# HYUNDAI Technical Service Bulletin

| Number | 09-01-003        |

Subject  
**2007MY SONATA SUN VISOR REPLACEMENT  
 (SERVICE CAMPAIGN T74)**

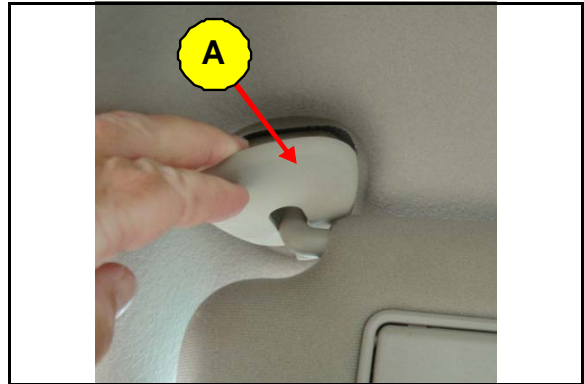
- Symptom/Condition  
 On some 2007MY Sonata (NF) vehicles, the sun visor pivot arm may crack or may not hold the desired position.

- Countermeasure  
 Replace both left and right sun visor assemblies for customer satisfaction.

1. Remove the left sun visor arm cap (A) with appropriate plastic trim tool.

2. Remove both sun visor arm mounting screws.

3. Disconnect the wiring connector (B) and remove the left sun visor assembly.

4. Install a new left sun visor assembly following the removal procedure in reverse order.
5. Repeat steps 1-4 and install a new right side sun visor assembly.
6. Open vanity mirror lid and verify light turns on.
